DELEGATED DECISION REPORT

SMD/2025/0493
Valid 26/11/2025

GATE FARM FOXT ROAD
FOXT

**EXTERNAL ALTERATIONS TO
DWELLING, DEMOLITION AND
REBUILDING OF WALL AND
INSERTION OF PEDESTRIAN GATE.
(FULL - MINOR)**

Fig.1 c.1881 OS map [online] (National Library of Scotland)

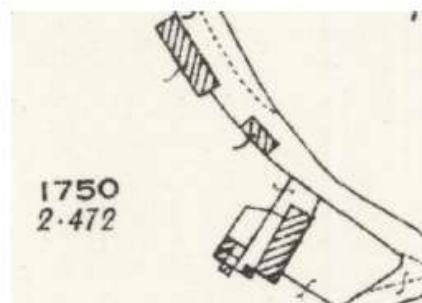
It is noted in the Heritage Statement that there have been various field parcel patterns around the farmhouse, notably groups of buildings to the west are shown on the 1843 tithe map (pg.9 of the Heritage Statement) and the farm layout is different by the late-19th and early-20th century mapping (see Fig.1 & 2). However, the current layout only includes the barn to the west (separately listed), a former stable along the lane and the farmhouse which is tightly enclosed to the west by a boundary wall and a garden to the east. It is not clear if this was the immediate curtilage and setting at the time of listing (listed in 1986) as the 1960s OS mapping still shows a building to the southwest. Nevertheless, the historic mapping does not appear to show that this was the 'domestic' curtilage of the farmhouse as it implies it was agricultural as it is still separately divided from the dwelling on the mapping. We would defer to planning officer as to whether there are conflicts with the rest of the development plan in regards to the principle of extending the domestic curtilage.
